**N5230A-06****S E R V I C E N O T E**Supersedes:  
NONE**N5230A PNA-L Series RF Network Analyzers****Serial Numbers: MY00000000 / MY46401145****Add-on mechanical components to enhance instrument reliability****To Be Performed By: Agilent-Qualified Personnel or Customer with specific product repair knowledge – requires instrument disassembly and component replacement.****Parts Required:**

ADDITIONAL INFORMATION: This service note (written May 9, 2008) applies to all N5230A being manufactured before this serial number MY46401146. The unit serial number is found at the back of the instrument. This Service Note must go along together with the instrument model Service Guide during modification.

McMaster Carr item 6959A18 (T-10 torx size L-key)

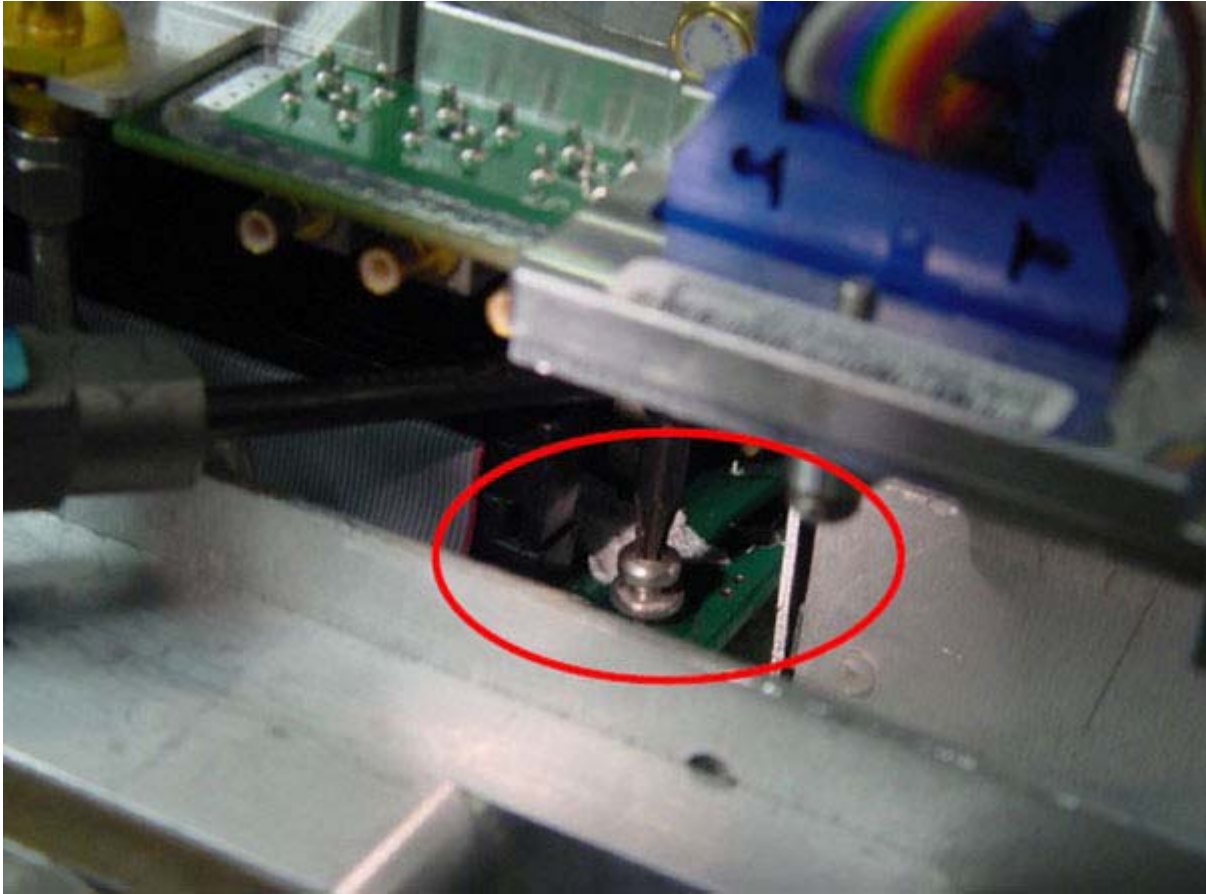
- b. Remove the open end head by loosening set screw. It will be replaced with L-Key shown below.

- c. Secure and orient the L-Key to the breakaway handle

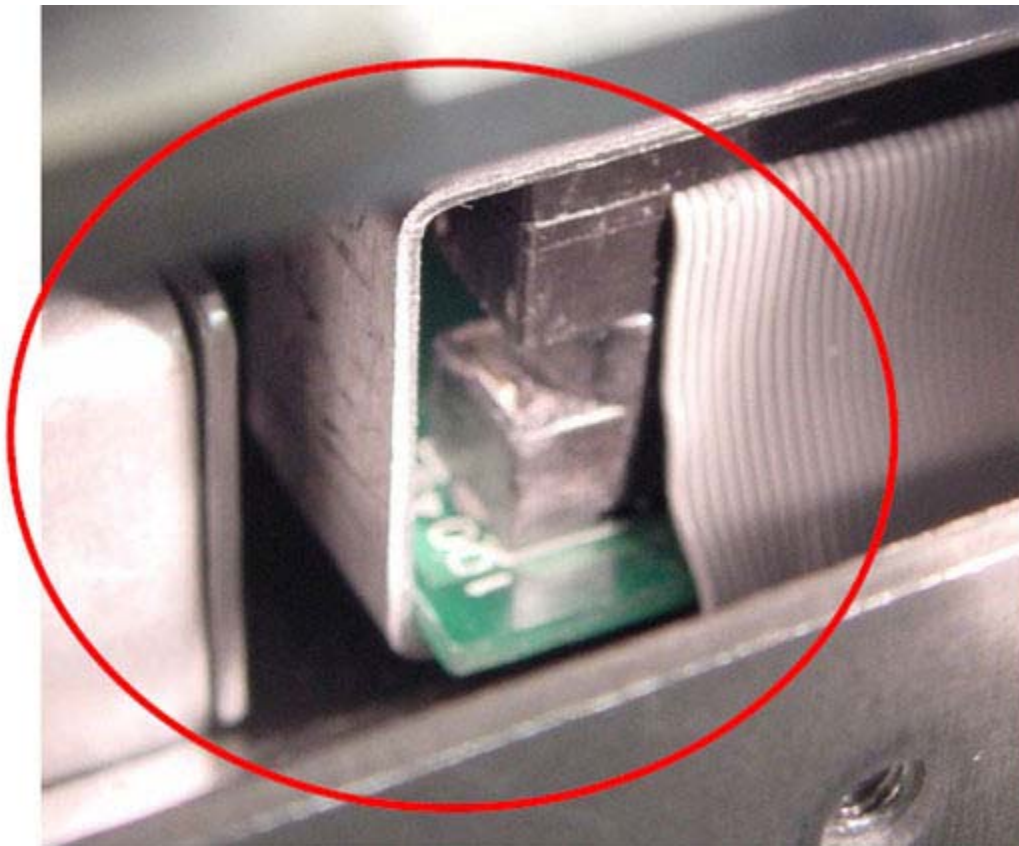
- a. Remove and discard existing screw near ribbon cable connector on System Motherboard. See below.

- b. Insert Ribbon Cable Clamp under Source Assembly as shown.

- c. Position the clamp over the Ribbon Connector. Use needle nose pliers if necessary to slide the clamp into place. Ensure that the edge of the clamp is parallel to the connector and not skewed.

**NOTE: Ensure that the Clamp Lip is secured BELOW the edge of the System Motherboard**

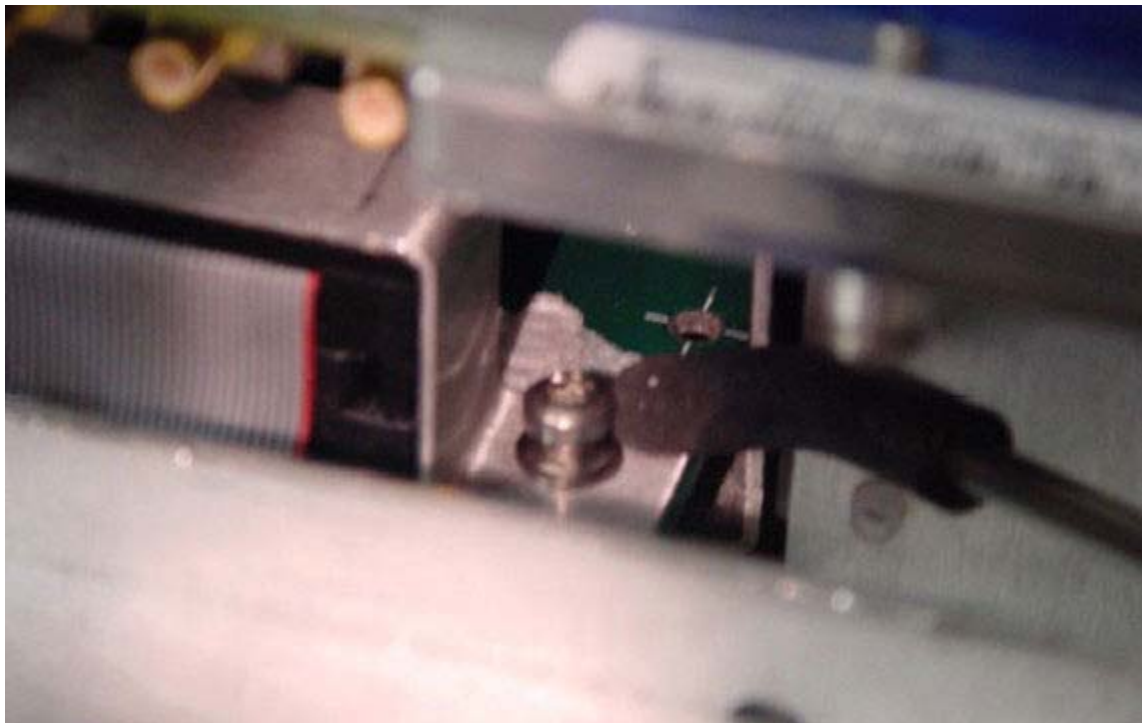
- d. Using tweezers, install a new 0515-0374 screw through the hole in the bracket.

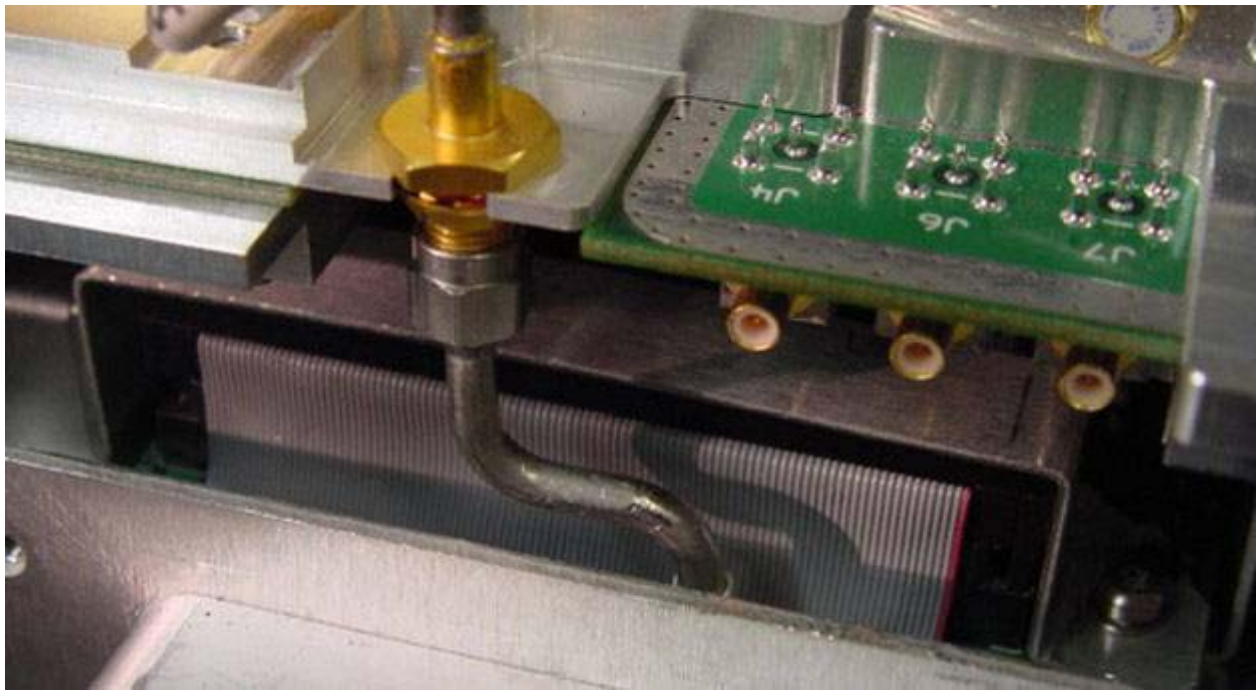
- g. This image shows the final position of the secured clamp.

- e. Use a nut runner tool (T-316130) or alternatively a clean erasure end of a pencil to help run the screw.

- f. Secure screw using the modified 10 lb-in breakaway wrench.

Figure 2a

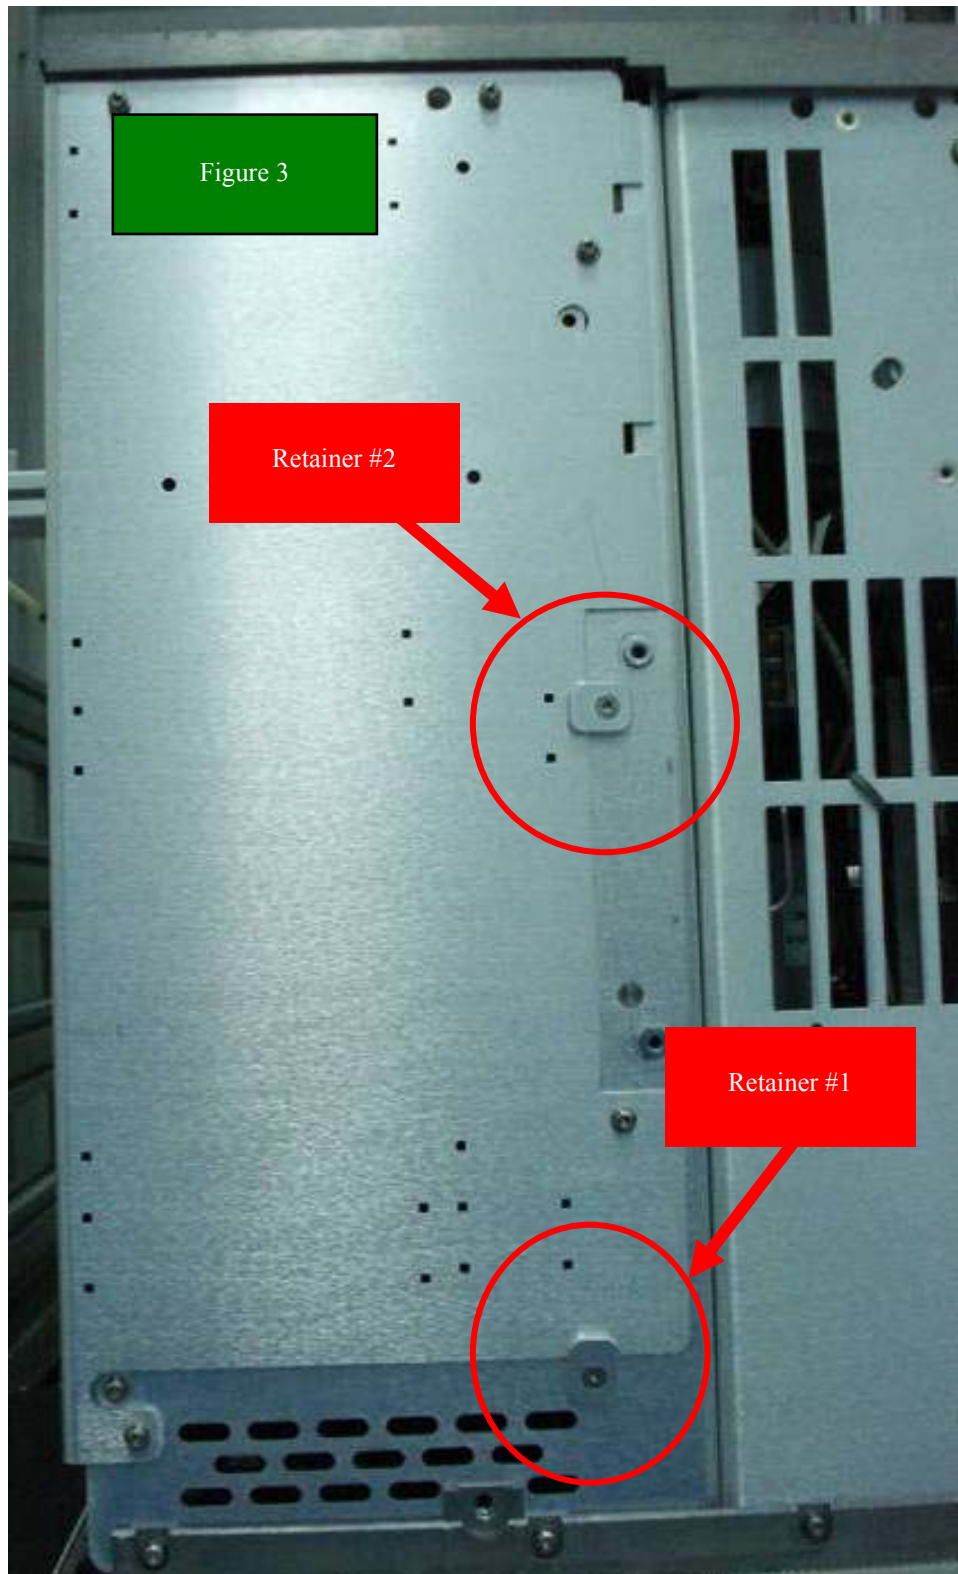
The Clip Retainer (E8361-20067) to be secured with Flat Head screw (0515-1644) in 2 places at 9 lb-in. This Retainer Clip may naturally rotate a bit when being secured, which is acceptable. Note that the existing screw needs to be removed and discarded prior installing Retainer Clip #1 (shown below in Figure 2a, 2b and 3). The final replacement out is as shown in Figure 3.
